PROPOSED OFFICE BUILDING

111 MAPLEWOOD AVENUE
PORTSMOUTH, NEW HAMPSHIRE

PROJECT NO: K-0076-019

**TAC SUBMISSION
COMPLETE SET 30 SHEETS**

UTILITIES PLAN
SCALE: AS SHOWN
C-104.1

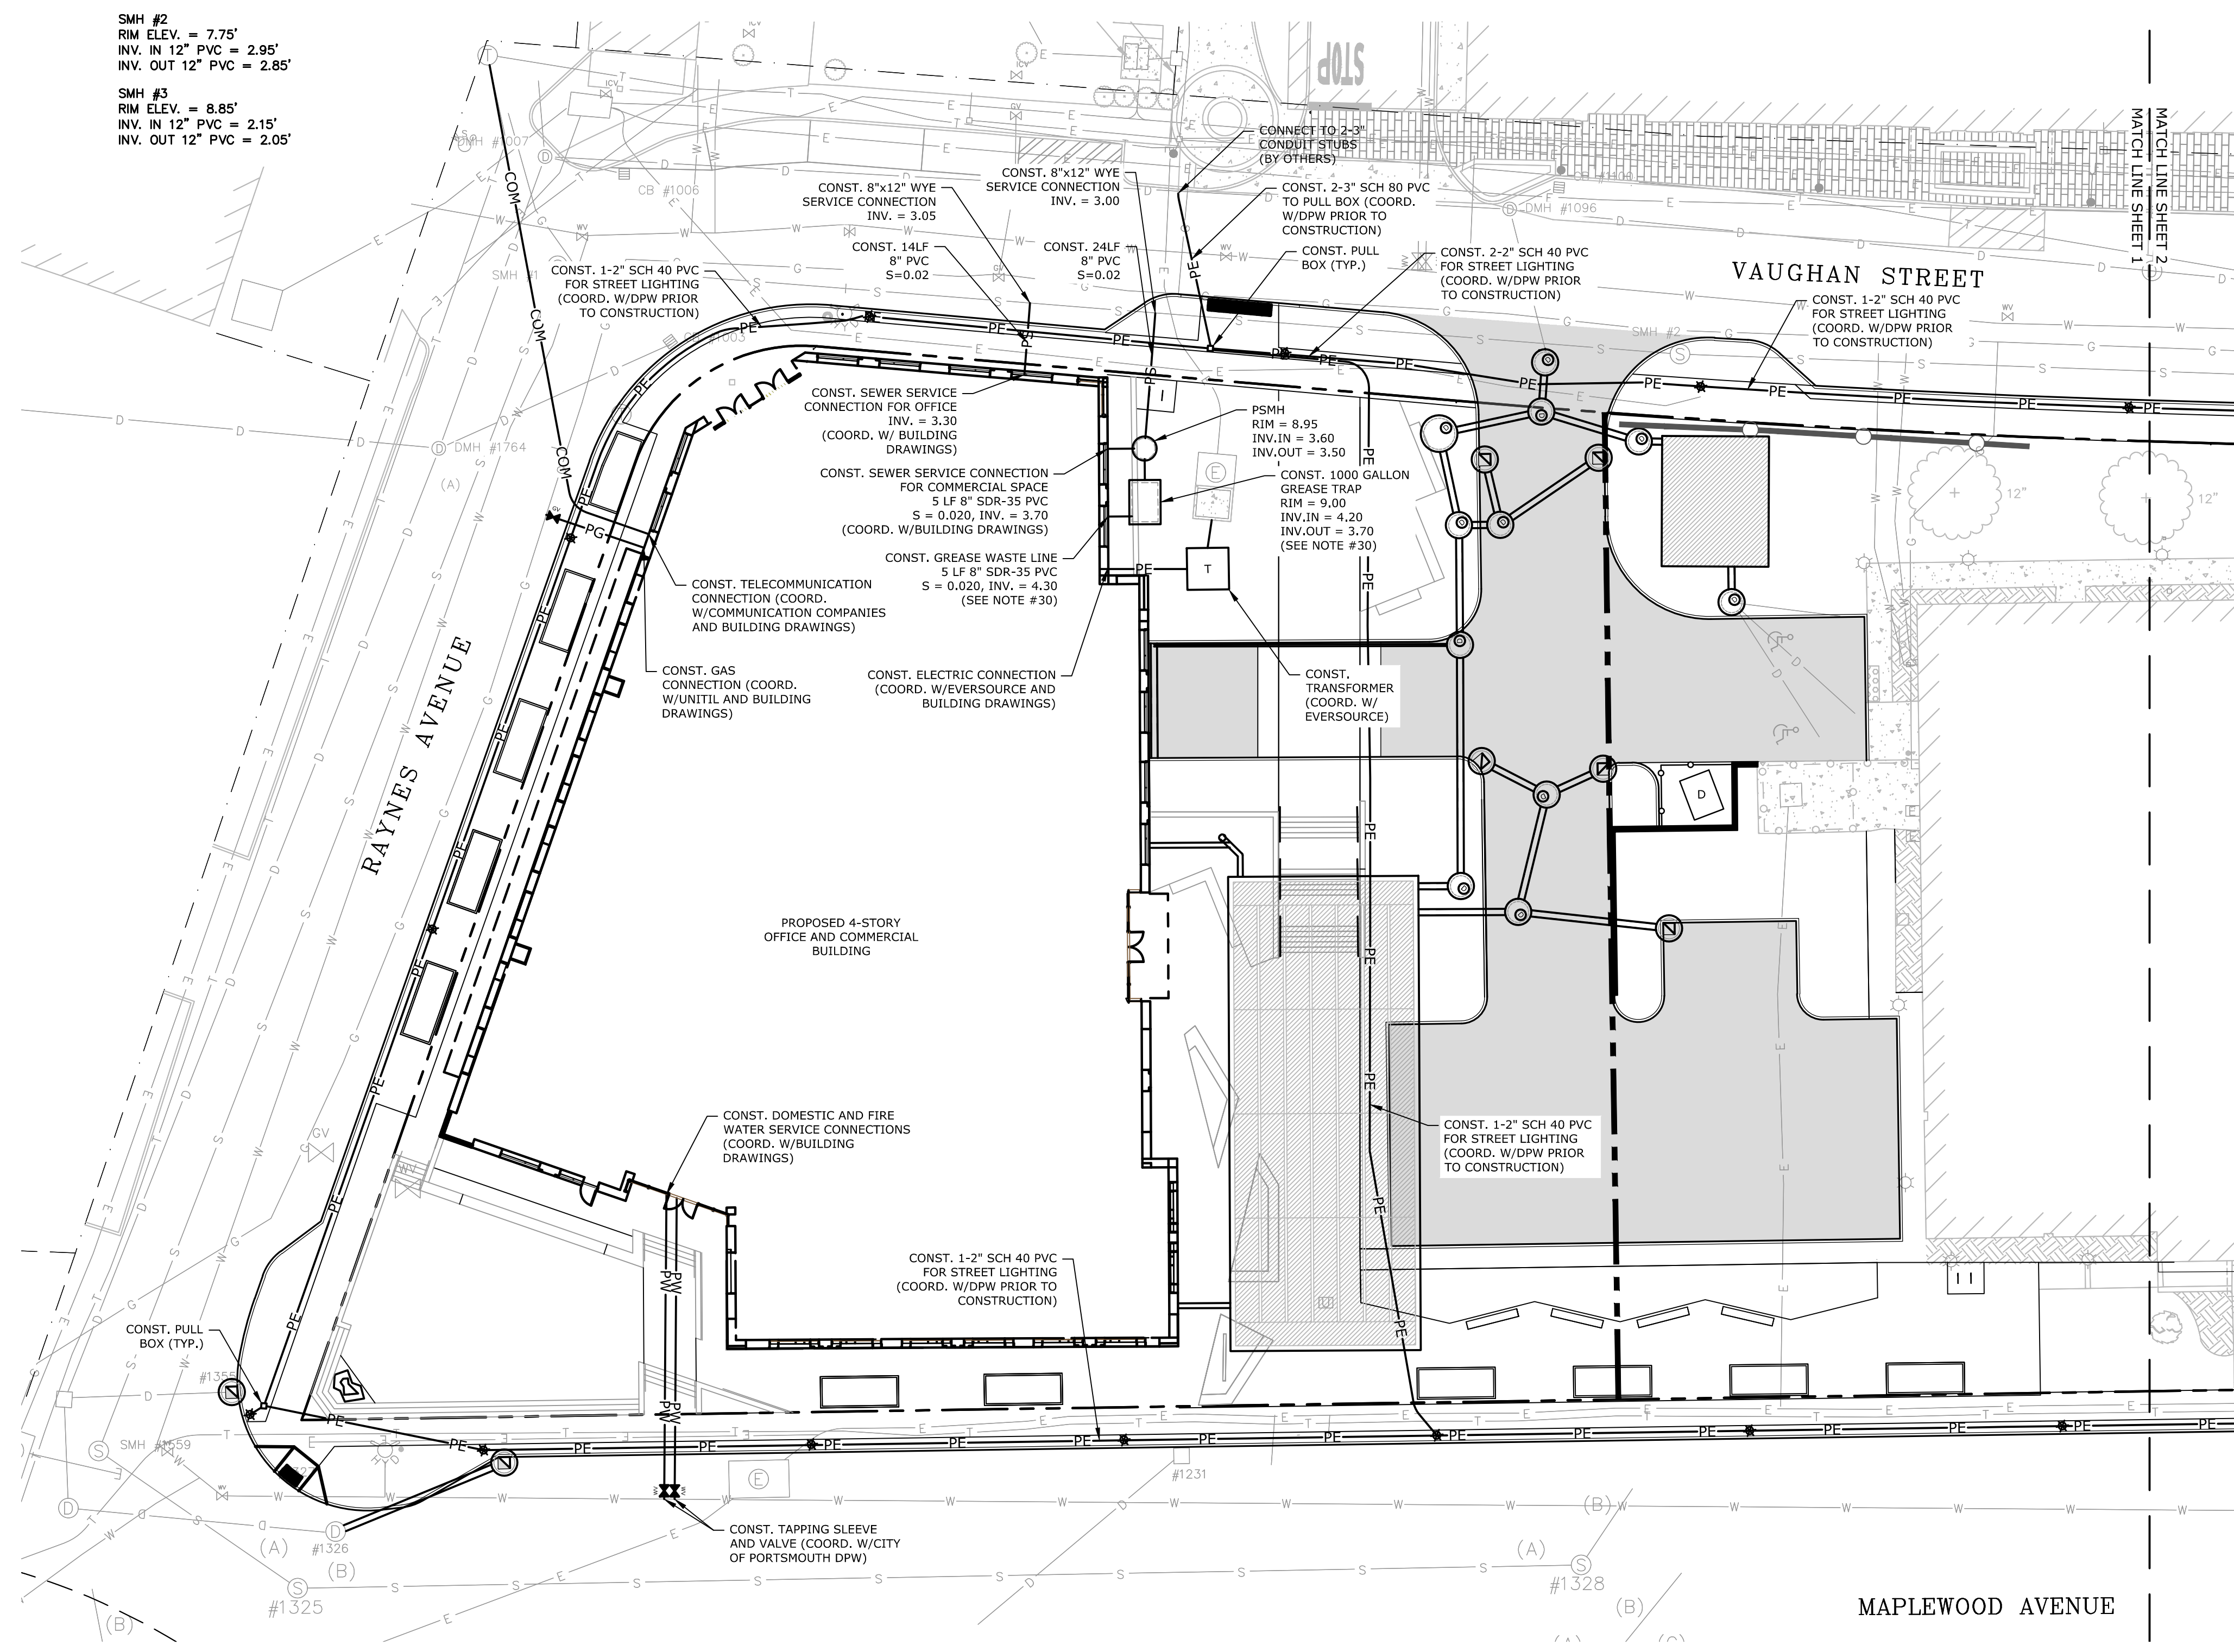
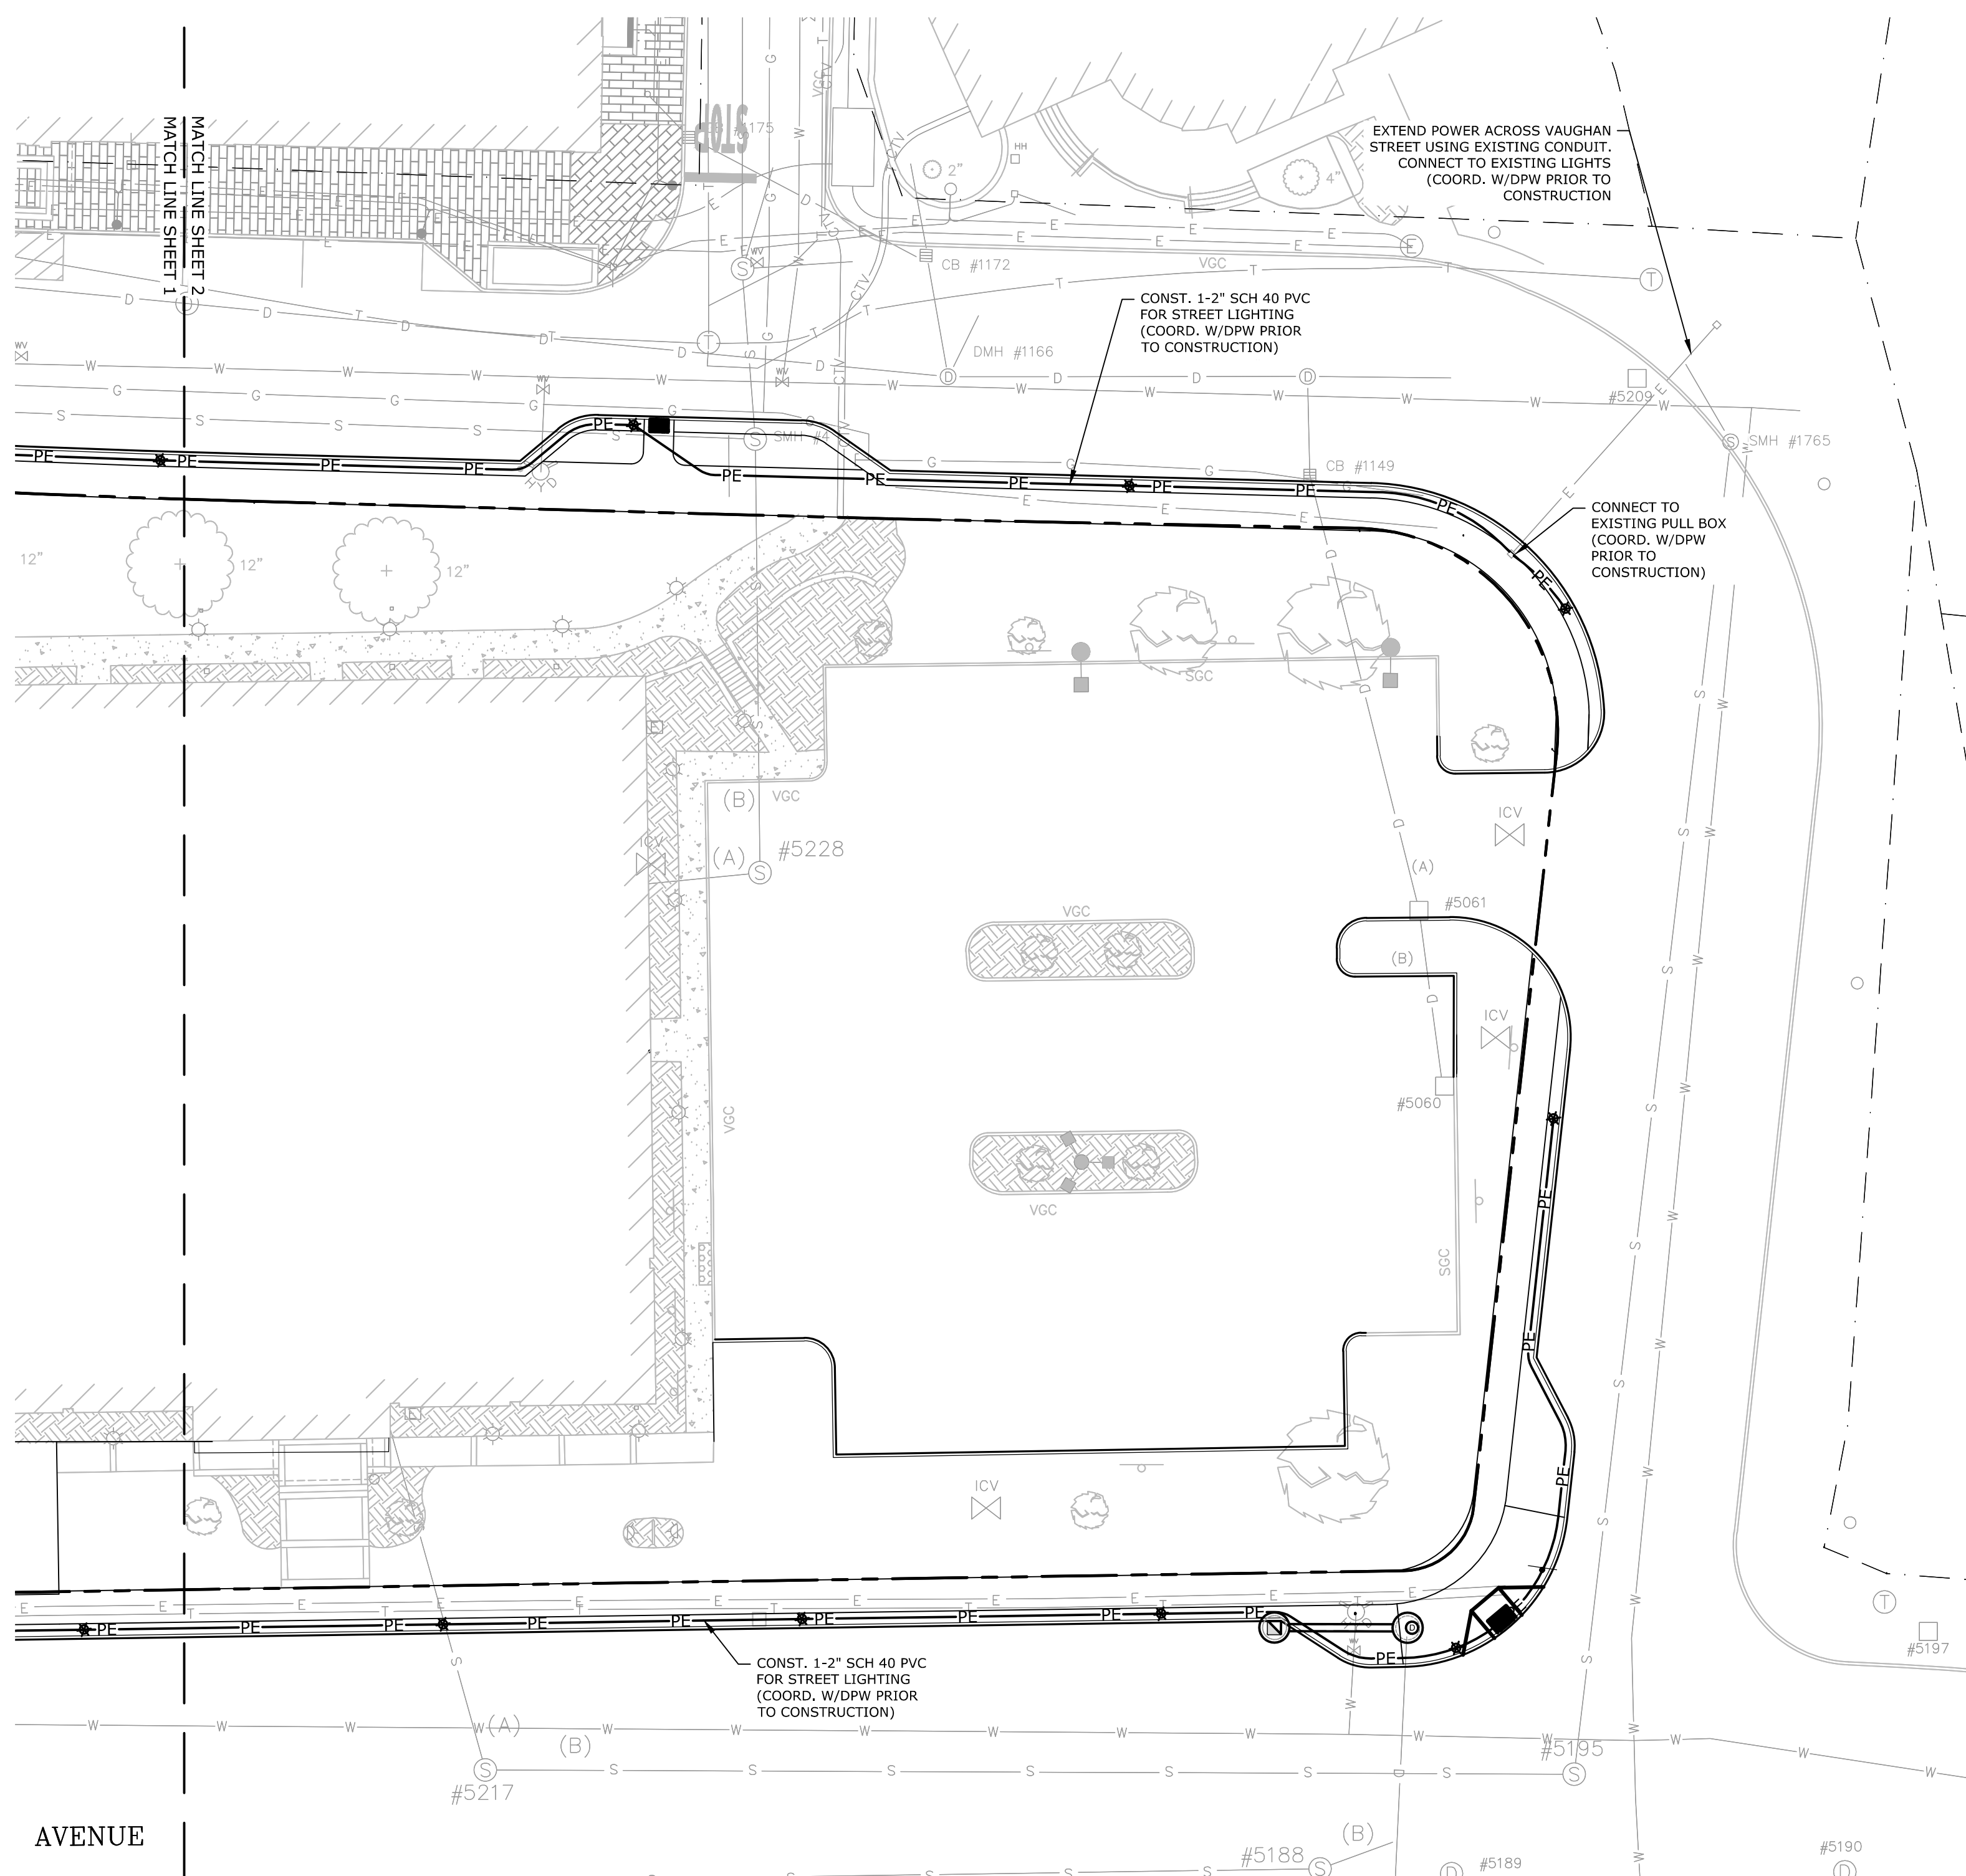
2	Appropriate contribution to improvements to the Russell St intersection will be required	As per Note #21 on the Site Plan, the value of a fair share contribution towards off-site public improvement projects shall be agreed upon between the Applicant and City prior to final approvals.	C-102.1 & C-102.2
3	All remaining existing lighting standard lights on Maplewood (in project area) Raynes Ave and Vaughan St to be removed as part of this approval	All street lighting on Maplewood, Raynes and Vaughan are to be removed and replaced as part of this project. The notations on the demolition plans have been revised to note the number of existing fixtures that are to be removed.	C-101.1 & C-101.2
4	Provide updated plans to City for construction of sewer this spring indicating sewer lateral locations	The City's sewer construction plans previously prepared by the applicant's engineer will be updated to include sewer lateral locations for this project prior to the sewer upgrades that will be constructed this Spring by the City. In addition, Note #31 has been added to the Utility Plan to indicate this.	C-104.1

8	There are gas and telephone lines going through proposed planters, please revise	Proposed gas and communications services shown on Raynes Ave have been revised to avoid conflict with the proposed street trees.	C-104.1
9	Actual locations of utility lines to site to be approved by City of Portsmouth	Confirmed.	C-104.1
10	8" Domestic water is oversized	Service connections have not been sized yet. A note has been added to indicate that final water service size and location shall be coordinated with the Building Drawings and DPW prior to construction.	C-104.1
11	Reclamation of Raynes Ave and overlay of all remaining bindered areas in the Raynes/Vaughan Area to be provided, details approved by DPW	As per Note #21 on the Site Plan, the value of a fair share contribution towards off-site public improvement projects shall be agreed upon between the Applicant and City prior to final approvals.	C-102.1 & C-102.2
